ACCESS REPORT

PROJECT APPLICATION

FRASERS BROADWAY - BLOCK 2

20-102 BROADWAY
SYDNEY

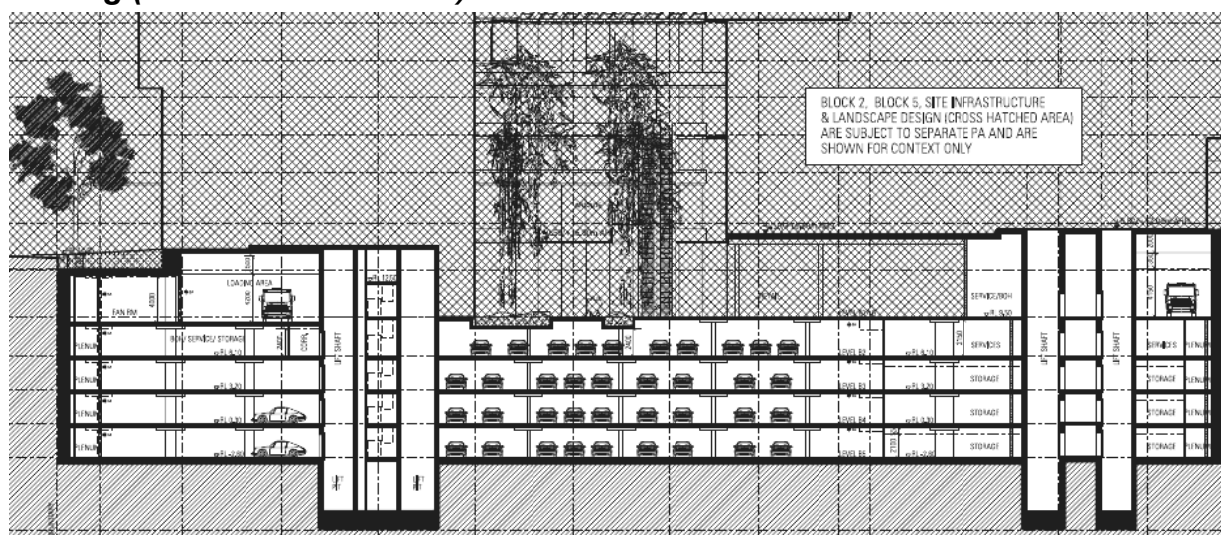
BCA Compliance	Complies
thereby enables equitable access.	
2. Within the central arcade areas the plans indicate several ramped sections to ensure equitable and direct access to all areas including the commercial lifts 6 and 7. The construction documentation shall ensure that doorways to enter tenancies shall incorporate level landings rather than ramped arcade accessways.	YES

3. Details of ramp and stairway handrails, tactile ground surface indicators and luminance contrasting step nosings shall be confirmed at construction certificate stage in accordance with ASI428 to satisfy Parts D3.2, D3.3, D3.8 of the BCA.	YES

4. With regard to doorway circulation space the plans indicate doors which facilitate appropriate circulation space to comply with ASI428.1 and Parts D3.2 and D3.3 of the BCA.	YES

5. Subject to details of door schedule and door hardware to provide 850mm clear opening widths with lever and D-pull handles the development will comply with ASI428.1 and Parts D3.2 and D3.3 of the BCA.	YES

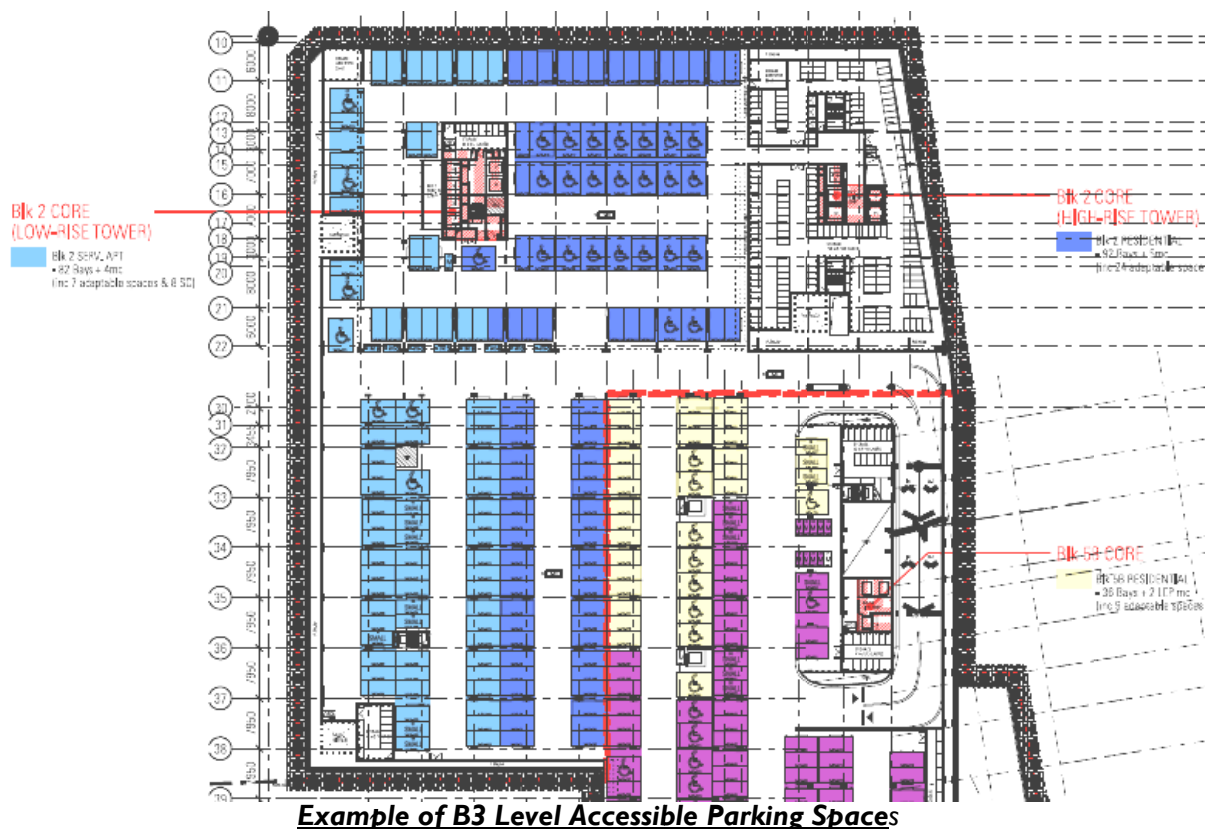
BCA Compliance	Complies
6. The development proposes 1,230 car spaces within a four level basement carpark (plus loading dock Level) which is to be shared for the residential / retail and commercial development associated with Blocks 2, 3, 5, 6, 7, 9. and 10.	
7. With respect to Block 2 the carpark proposes 539 parking spaces configured as follows: <ul style="list-style-type: none"> 438 residential apartment spaces including 90 X 3800mm spaces for the adaptable apartments to satisfy AS4299 and Council's Access DCP. 58 retail spaces including 3 X 3800mm accessible spaces to satisfy Table D3.5 of the BCA, AS2890.1 and Council's Access DCP. 43 service vehicle spaces including 3 X 3800mm accessible spaces. 	YES
8. The accessible 2300mm minimum height clearances and 2500mm height over the	YES

BCA Compliance	Complies
<p>accessible spaces will readily comply with AS4299, Council's Access DCP and also satisfy AS2890.1 and Part D3.5 of the BCA.</p> <p>9. The accessible parking will be situated on generally level pavement no steeper than 1:40 to comply with AS2890.1.</p> <p>10. The locations of the accessible parking adjacent the lift landings are convenient and enable direct access to the lift landings, <u>except for the B2 level access corridor to the Apartment lift lobby, which can readily be adjusted to 1600mm minimum width at construction certificate stage.</u></p>	<p>YES</p> <p>YES</p> <p>YES at CC stage</p>

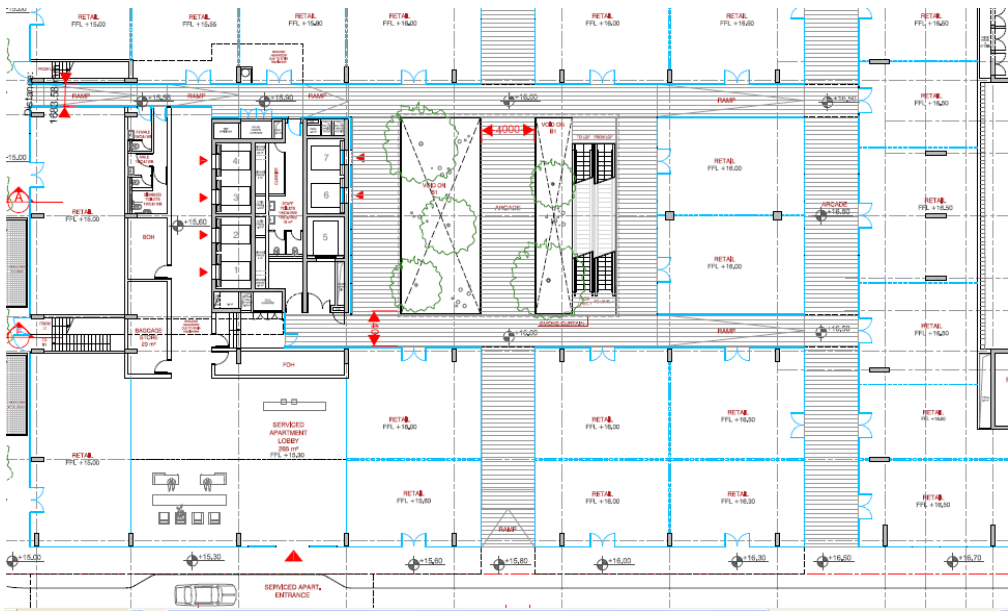
BCA Compliance	Complies
<p>11. Lower Ground Floor - Supermarket – The base building plan for the lower ground floor retail supermarket provides an open plan layout with vertical access via Lifts 6 and 7 which travel from ground to lower ground and retail parking on Levels B2 and B3. Overall there are no access barriers to prevent compliance with AS1428.1 and Part D3.3 of the BCA.</p>	<p>YES</p>

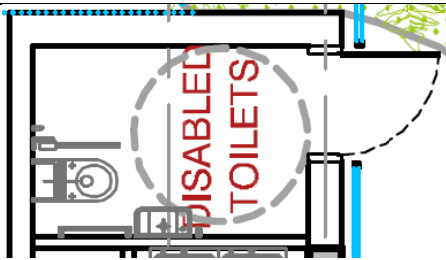
BCA Compliance		Complies
40. Level 4 Swimming Pool facilities providing <u>1700mm X 2400mm</u> requires an increase to <u>2400mm X 2400mm</u> to accommodate an accessible shower and comply with <u>AS1428.2</u> to satisfy Council's Access DCP and Part F2.4 of the BCA.		YES at CC stage

Level 1 Residents Library

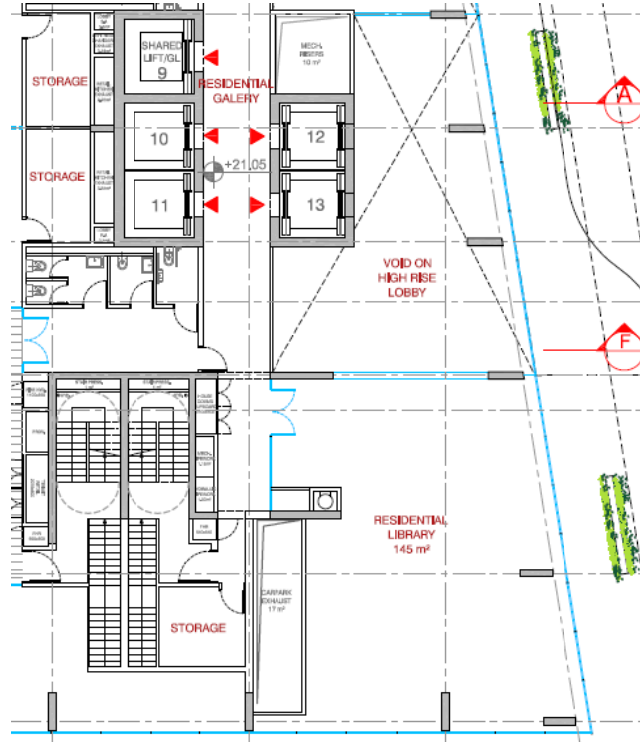
adjacent to the lift lobby which provides convenient access to residents. The lift lobby also provides a through link to the level 1 retail and accessible toilets.

Subject to the confirmation of 920mm minimum width doors and level doorway thresholds in accordance with ASI428.1 and ASI428.2 it is apparent that these common facilities will be accessible to residents and staff and thereby comply with Council's Access DCP, AS4299 and SEPP 65.

Level 4 Swimming Pools

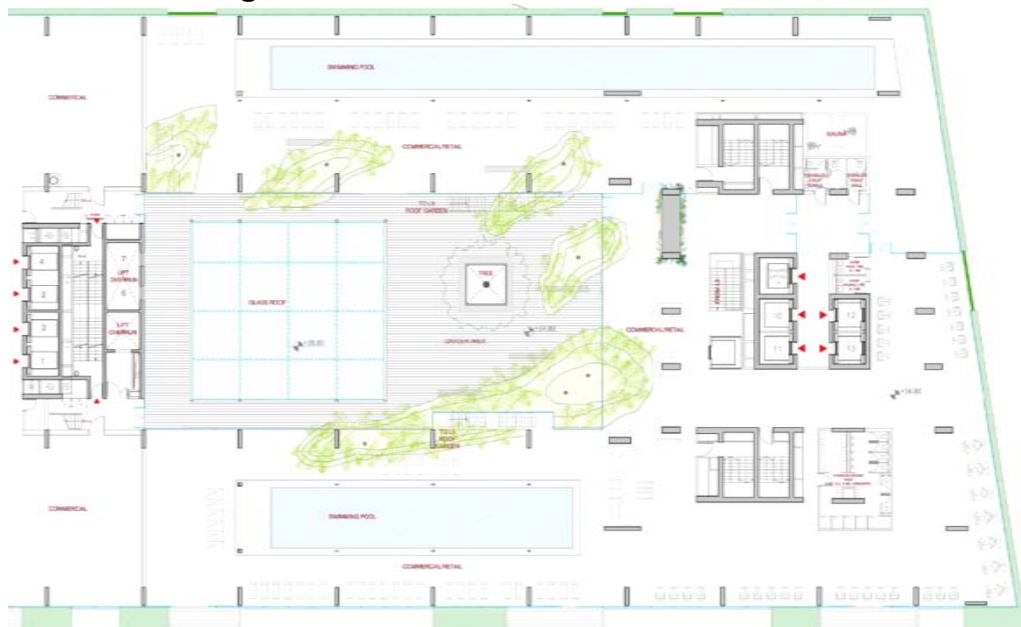
Level 4 proposes swimming pools and associated sanitary facilities that will incorporate on-grade level access from adjoining lift lobbies.

The unisex accessible bathroom that is designed to comply with ASI428 and Council's Access DCP, subject to the room being increased to at least 2400mm X

Clause	Adaptability Assessment – Common Domain areas	Compliance
	2400mm to accommodate a shower.	
	Subject to the confirmation of doorway locations, 920mm minimum width doors, level doorway thresholds in accordance with AS1428 and enhancement to the accessible toilet to include a shower then it is apparent that these common facilities will be accessible to residents and thereby comply with Council's Access DCP, AS4299 and SEPP 65.	
AS4299 Cls 3.3.3, 3.7 & AS2890.5	<p>Car Parking</p> <p>The development proposes 1,230 car spaces within a four level basement carpark (plus loading dock Level) which is to be shared for the residential / retail and commercial development associated with Blocks 2, 5 and 9.</p> <p>With respect to Block 2 Residential the carpark proposes 438 residential apartment spaces including 90 X 3800mm spaces for the adaptable apartments to satisfy AS4299 and Council's Access DCP.</p> <p>The accessible 2300mm minimum height clearances and 2500mm height over the accessible spaces will readily comply with AS4299, Council's Access DCP and also satisfy AS2890.1 and Part D3.5 of the BCA.</p> <p>The accessible parking will be situated on generally level pavement no steeper than 1:40 to comply with AS2890.1.</p> <p>The locations of the accessible parking adjacent the lift landings are convenient and enable direct access to the lift landings,</p>	<p>YES</p> <p>YES</p> <p>YES</p> <p>YES</p>

Clause	Adaptability Assessment – 1 Bedroom Type RE.B2.05 & RE2.06 Complies
--------	---

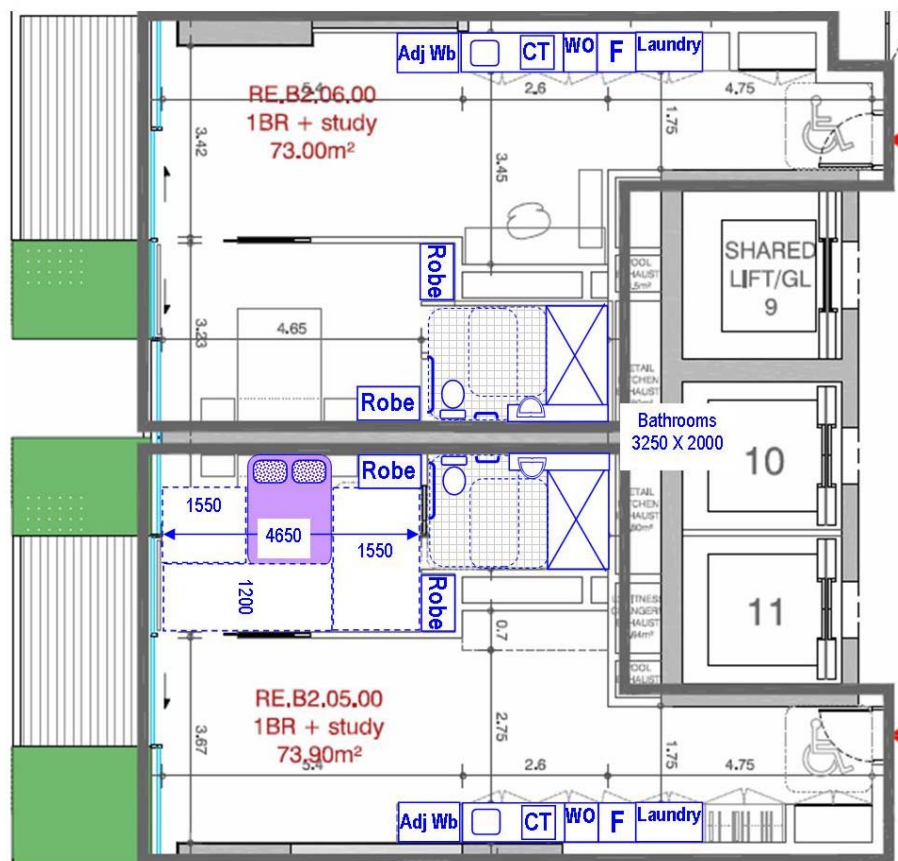
AS4299 Clauses 4.3.1, 4.3.2 and 4.3.3	Accessible entry – The front entrance to these units provides at least 1550mm X 1550mm externally in the common corridors and internally with 520mm minimum latch side clearance, which complies with the spatial requirements of AS4299.	YES
	Internally the 1550mm wide entry foyer area provides the required 1550mm X 1550mm minimum circulation area.	YES
AS4299 Cls 4.3.7	Interior: general – The pre adaptation plan provides an open plan living area with direct access to the bedroom doorway in accordance with AS1428.1/4299.	YES
	The post adaptation plan illustrates a minor modification to the bedroom robe / bathroom wall which facilitates enhanced doorway circulation space within the bathroom to comply with the minimum doorway circulation space requirements of AS1428/4299.	YES
	Doors and Door Hardware While the plans do not indicate 920mm external door widths, 870mm internal door widths and lever handles these details should be provided at construction drawing stage to confirm compliance.	YES

Clause	Adaptability Assessment – 1 Bedroom Type RE.B2.05 & RE2.06	Complies
AS4299 Clause 4.7	Living and Dining rooms – The plans show combined living and dining area on a single level with sufficient area to provide a 2250mm diameter turning area to comply with this clause.	YES
AS4299 Clause 4.5	Kitchen – The single galley kitchen inherently provides the required 1550mm X 1550mm minimum circulation space adjacent the benches to comply with AS4299 requirements. With regard to the “adaptability” of the kitchen the pre-adaptation plan provides an appropriate layout of sink, fridge, wall oven, cooktop while the post adaptation plan proposes a height adjustable workbench that is readily adaptable and satisfies the “ease of adaptation” guidelines outlined in section 2 – Performance Objectives of AS4299. Therefore, subject to confirmation of the installation of kitchen cupboards, appliances and the like at the construction documentation stage it is apparent that the kitchen will comply with AS4299.	YES YES

AS4299 Clause 4.6	Main bedroom – The post adaptation plan shows the main bedroom for these Units will be 4650mm X 3230mm, provides 1540mm X 2070mm circulation space adjacent and a 1000mm on either side of the queen sized bed to satisfy AS4299/1428.	YES
AS4299 Clause 4.7	Bathroom – The plans show the bathroom will be at least 2000mm X 3250mm with a layout of sanitary facilities that is readily adaptable to comply with AS1428/4299 by re-directing plumbing services within the bulkhead wall. I am also satisfied that the location of the WC pan, washbasin and shower/bath in pre and post adaptation satisfy the performance requirements of AS4299.	YES
AS4299 Cls 4.4.3	Toilet – The size and layout of the bathroom enables the toilet to comply with AS4299 by providing 1250mm X 900mm in front of the WC pan.	YES
AS4299 Clause 4.8	Laundry – The laundry closet adjacent to the 1550mm width entry foyer provides adequate space for a washing machine/drier while the adjacent area facilitates the required minimum 1550mm X 1550mm clear circulation space in front of the appliances to comply with AS4299.	YES

AS4299 Cls 3.5(b)	Outdoor Private Open Space – The plans show outdoor balcony terrace areas adjacent living areas for each of these units with sliding doors for convenient access and an approximate 2100mm width X 3800mm length, which is adequate to perform a 180 degree wheelchair manoeuvre. While the plans do not indicate thresholds the construction drawings will confirm a 50mm maximum with the capability for threshold ramps to comply with AS1428/4299.	YES

Clause	Adaptability Assessment – 2 Bedroom Type rc3.01 Layout	Compliance
--------	--	------------

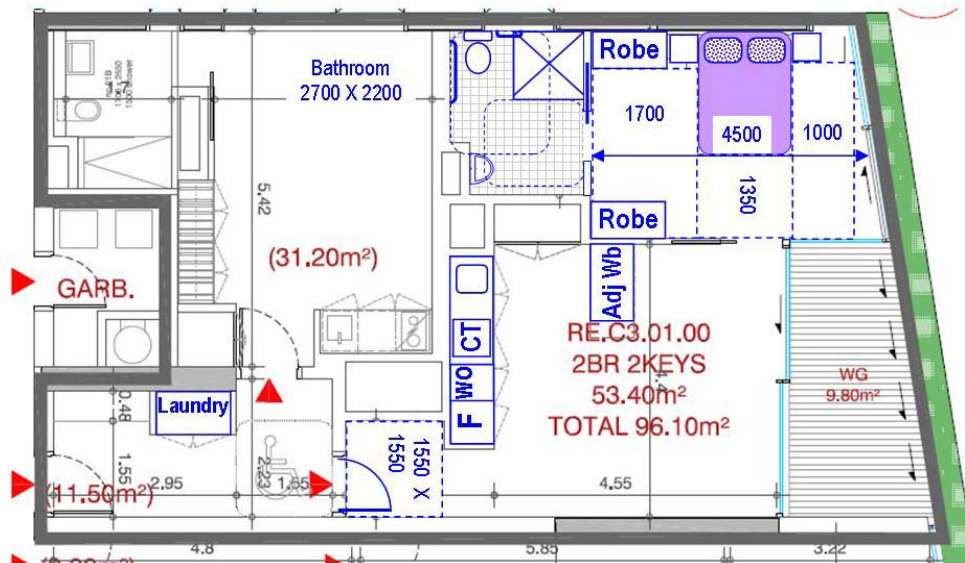
Accessible entry – The front entrance to these units provides at least 1550mm X 1550mm externally in the common corridors and internally with 520mm minimum latch side clearance, which complies with the spatial requirements of AS4299.

Internally the 1550mm wide entry foyer area provides the required 1550mm X 1550mm minimum circulation area.

Interior: general – The pre adaptation plan provides an open plan living area with direct access to the bedroom doorway in accordance with AS1428.1/4299.

While the plans do not indicate 920mm external door widths, 870mm internal door widths and lever handles these details should be provided at construction drawing stage to confirm compliance.

Living and Dining rooms – The plans show combined living and dining area on a single level with sufficient area to provide a 2250mm diameter turning area to comply with this clause.

Kitchen – The L-shaped kitchen illustrates at least 1550mm X 1550mm minimum circulation space adjacent the benches to comply with AS4299 requirements.

With regard to the “adaptability” of the kitchen the pre-adaptation plan provides an appropriate layout of sink, fridge, wall oven, cooktop and height adjustable workbench that is readily adaptable and satisfies the “ease of adaptation” guidelines outlined in section 2 – Performance Objectives of AS4299.

Clause	Adaptability Assessment – 2 Bedroom Type rc3.01 Layout	Compliance
stage it is apparent that the kitchen will comply with AS4299.		
AS4299 Clause 4.6	Main bedroom – The main bedroom for these Units will be 4500mm X 3350mm, which provides 1540mm X 2070mm circulation space adjacent and a 1000mm on either side of the queen sized bed to satisfy AS4299/1428.	YES
AS4299 Clause 4.7	Bathroom – The plans show the main bedroom bathroom will be at least 2200mm X 2700mm with a layout of sanitary facilities that is readily adaptable to comply with AS1428/4299. I am also satisfied that the location of the WC pan, washbasin and shower/bath in pre and post adaptation satisfy the performance requirements of AS4299.	YES
AS4299 Cls 4.4.3	Toilet – The size and layout of the bathroom enables the toilet to comply with AS4299 by providing 1250mm X 900mm in front of the WC pan.	YES
AS4299 Clause 4.8	Laundry – The laundry closet adjacent to the living area provides adequate space for a washing machine, drier and basin, while the adjacent area facilitates the required minimum 1550mm X 1550mm clear circulation space in front of the appliances to comply with AS4299.	YES

AS4299 Cls 3.5(b)	Outdoor Private Open Space – The plans show outdoor balcony terrace areas adjacent living areas for each of these units with sliding doors for convenient access and an approximate 1600mm-2400 width X 4400mm length, which is adequate to perform a 180 degree wheelchair manoeuvre. While the plans do not indicate thresholds the construction drawings will confirm a 50mm maximum with the capability for threshold ramps to comply with AS1428/4299.	YES

Clause	Adaptability Assessment – 1 Bed Types RW.A1 & RW.B1	Complies
--------	---	----------

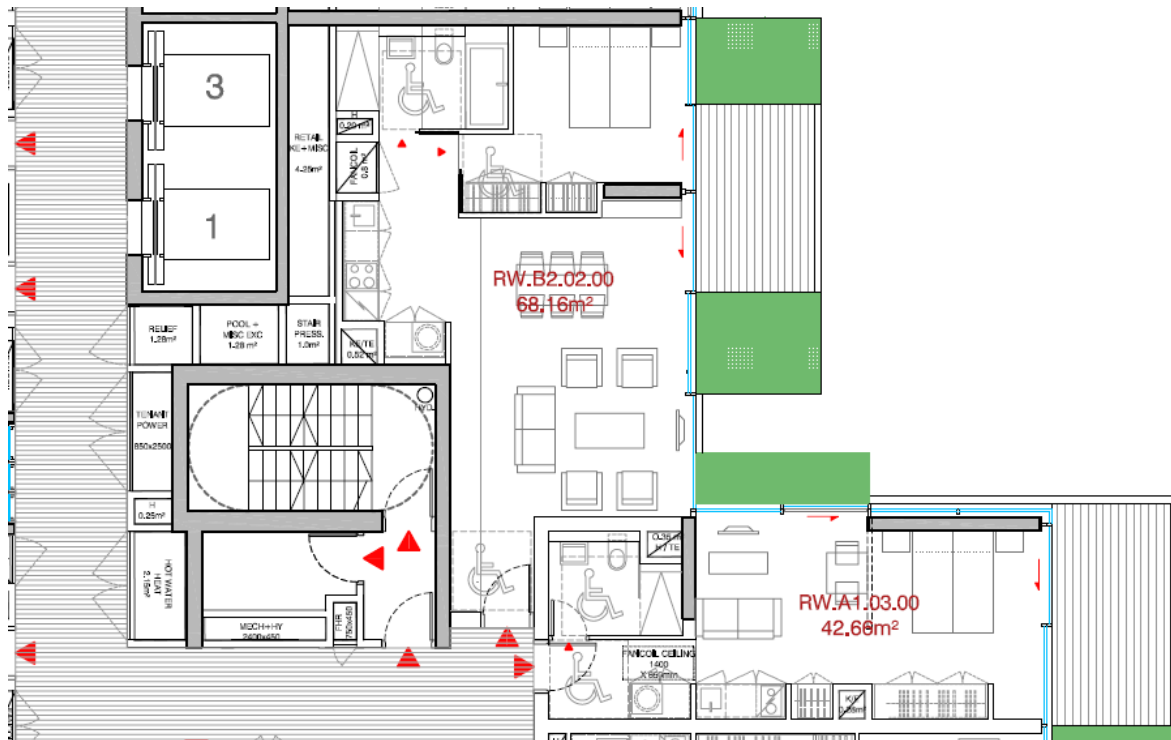
AS4299 Clauses 4.3.1, 4.3.2 and 4.3.3	<p>Accessible entry – The front entrance to these unit types provides at least 1550mm X 1550mm externally in the common corridor and internally with 520mm minimum latch side clearance, which complies with the spatial requirements of AS4299.</p> <p>Internally the 1550mm wide entry foyer area provides the required 1550mm X 1550mm minimum circulation area.</p>	YES
AS4299 Cls 4.3.7	<p>Interior: general – The plan illustrates that the bedroom door and robe could be readily modified to facilitate enhanced doorway circulation space to a <u>main bedroom</u> to comply with the minimum doorway circulation space requirements of AS1428/4299.</p> <p>Doors and Door Hardware</p> <p>While the plans do not indicate 920mm external door widths, 870mm internal door widths and lever handles these details should be provided at construction drawing stage to confirm compliance.</p>	YES

AS4299 Clause 4.7	<p>Living and Dining rooms – The plans show combined living and dining area on a single level with sufficient area to provide a 2250mm diameter turning area to comply with this clause.</p>	YES
AS4299 Clause 4.5	<p>Kitchen – The kitchen illustrates ample internal area to provide the required 1550mm X 1550mm minimum circulation space adjacent the benches to comply with AS4299 requirements.</p> <p>With regard to the “adaptability” of the kitchen the post-adaptation plan provides an appropriate layout of sink, fridge, wall oven, cooktop and to adjust the positions of a height adjustable workbench and appliances that is readily adaptable and satisfies the “ease of adaptation” guidelines outlined in section 2 – Performance Objectives of AS4299.</p>	YES

Clause	Adaptability Assessment – I Bed Types RW.A1 & RW.B1	Complies
	Therefore, subject to confirmation of the installation of kitchen cupboards, appliances and the like at the construction documentation stage it is apparent that the kitchen will comply with AS4299.	
AS4299 Clause 4.6	Main bedroom – The plan shows the main bedroom for these Units will be adequate in size to enable 1540mm X 2070mm circulation space adjacent and a 1000mm on either side of the queen sized bed to satisfy AS4299/1428.	YES
AS4299 Clause 4.7	Bathroom – The plans show ensuite bathrooms of appropriate sizes (average 1950-2150 X 3150-3300) with a layout of sanitary facilities that is readily adaptable to comply with AS1428/4299. I am also satisfied that the location of the WC pan, washbasin and shower/bath in pre and post adaptation satisfy the performance requirements of AS4299.	YES
AS4299 Cls 4.4.3	Toilet – The size and layout of the bathrooms enables the toilet to comply with AS4299 by providing 1250mm X 900mm in front of the WC pan.	YES

AS4299 Clause 4.8	Laundry – The laundry closet adjacent to the 1550mm width entry foyer provides adequate space for a washing machine, drier and basin, while the adjacent area facilitates the required minimum 1550mm X 1550mm clear circulation space in front of the appliances to comply with AS4299.	YES
AS4299 Cls 3.5(b)	Outdoor Private Open Space – The plans show outdoor balcony terrace areas adjacent living areas for each of these units with sliding doors for convenient access with a 3000mm minimum width X 4000-8000mm length deck areas, which are ample to perform a 180 degree wheelchair manoeuvre. While the plans do not indicate thresholds the construction drawings will confirm a 50mm maximum with the capability for threshold ramps to comply with AS1428/4299.	YES
